Product Change Notification

Date Issued :	October 17, 2022	PCN Number :	512851
Reason for Change :	Change to Product		
Description of Change :	Cable supplier informed Molex they will discontinue cables utilizing polyvinylidene fluoride (PVDF) compound. Replacement cable from same supplier will meet the same current specifications and compliance.		
Reason for Short Notice :	Supplier Constraints		
Assessment of Change :	Supplier Qualification Test Report/s		
Planned Implementation Date :	January 18, 2023		
Sample Availability Date:	November 15, 2022		
Internal Molex Qualification Date :	November 01, 2022		
Last date to request Samples by Customer :	December 01, 2022		
Traceability Code Markings / Date :	No special marking on the product or packaging

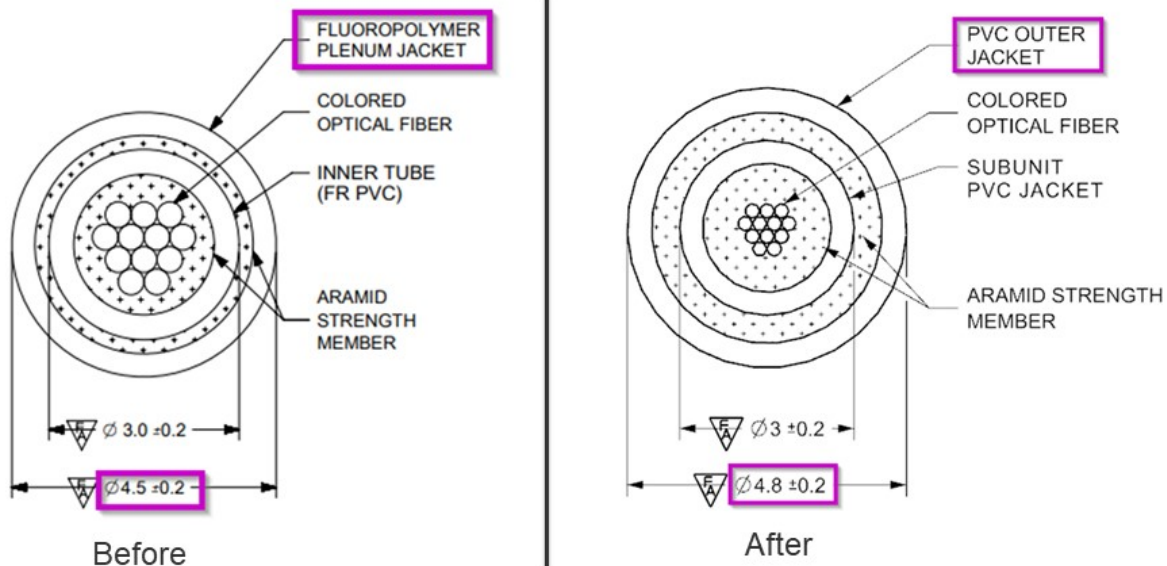
- Cable supplier informed us that they will discontinue cables utilizing polyvinylidene fluoride (PVDF) compound due to an indefinite stoppage in the manufacturing of this compound.
- Product Impact
 - OD of outer jacket will be slightly larger.
 - No change to the performance of the cable.
 - Replacement cable will meet the same current specifications and compliance.
- Part Number Impact
 - See attached impacted parts list
- Qualification Reports and samples available upon request.
